Technical Service Bulletin

MODEL(S) AFFECTED: **R3 ReadySpace® Carpet Cleaner**

SUBJECT: Scrubhead may sporadically drip during normal operation resulting in a water spot trail on the carpet.

Fig. 2

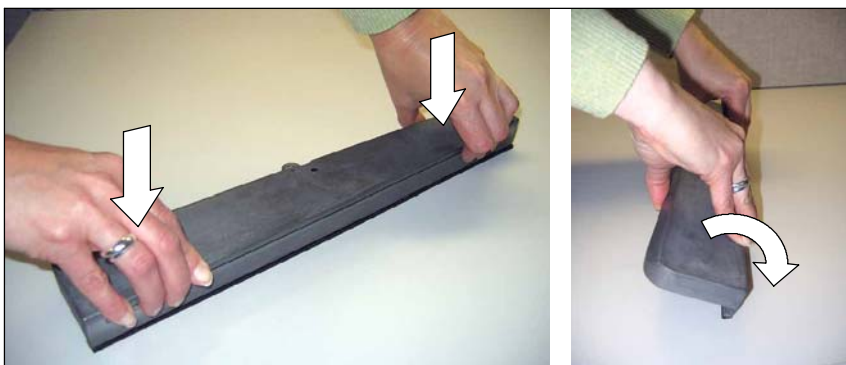
Overspray accumulation may drip off top edge of vacuum tool covers.

1. Remove the two vacuum tool covers (Figure 1).
2. Thoroughly clean the top edge of each vacuum tool cover.
3. Carefully adhere the foam gasket along the top edge of the vacuum tool cover (Figure 2).
4. Press the gasket against a flat surface and roll the vacuum tool cover forward to bond the gasket (Figure 3).
5. Replace the vacuum tool covers.

PURPOSE: To prevent the scrubhead from dripping, order the Foam Gasket Service Kit p/n 9006593.
